**Subject:** SolarForce 648 Buzzing Noise

**Number:** SRV0009

**Applicability:** SolarForce 648

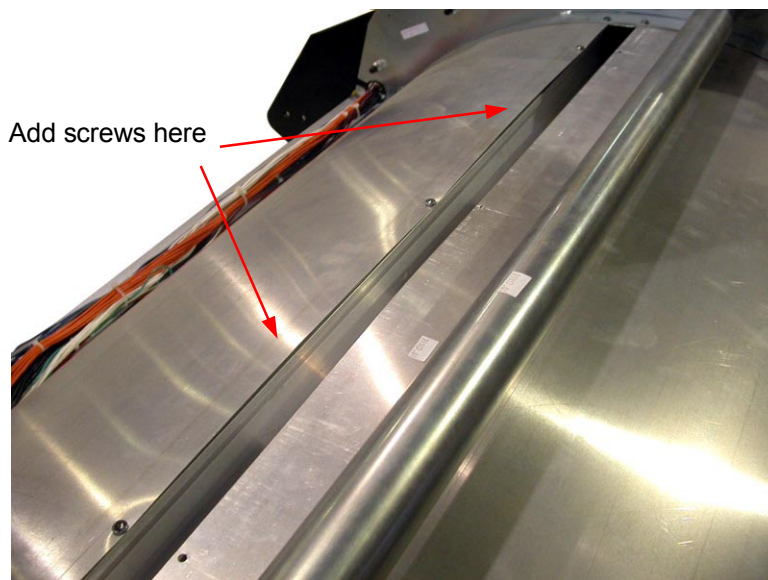
Unlock the canopy acrylic and remove it (see owners manual). At either end of the canopy, inside the tanning area are five (5) screws securing the endcaps to the unit (see picture below). Remove these screws, gently lift the endcap and remove it. Be careful! The head-end endcap has the timer display cable attached. Disconnect it.

Remove the vent hoses and power cables from the back of the canopy.
